# Product Change Notification

V 20180321

1. AMB2621, AMB2621-1, AMB2621-TR, AMB2621-1-TR, AMB2621-DEV, AMB2621-1-DEV

New footprint:

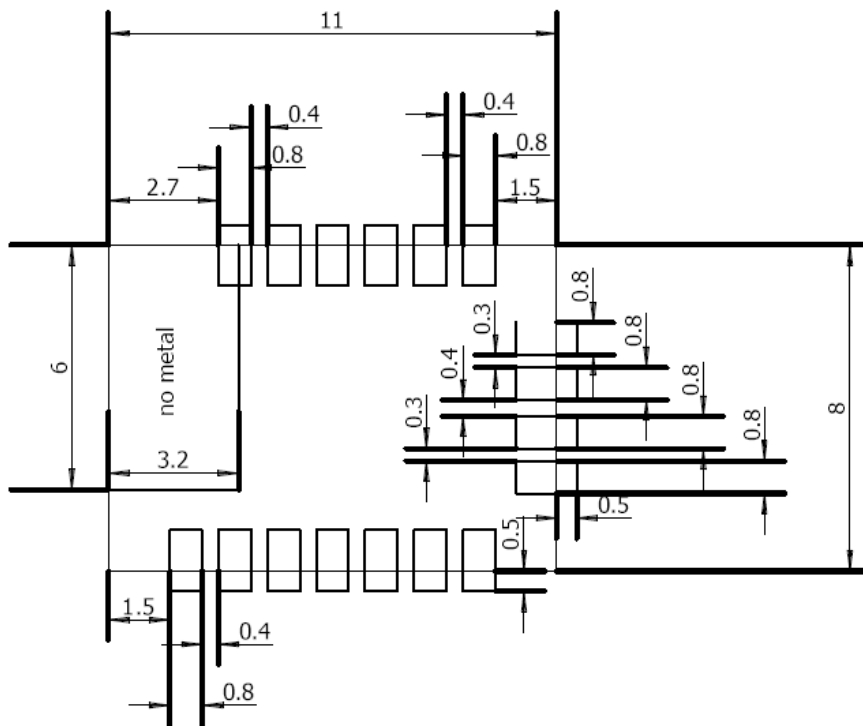
Change of documentation concerning footprint.

Due to a type error the recommended footprint differs about 0.1mm from the formerly recommended one. For future designs we recommend to follow the new drawings. Designs based on the formerly footprint may not be changed as the old footprint worked without errors.
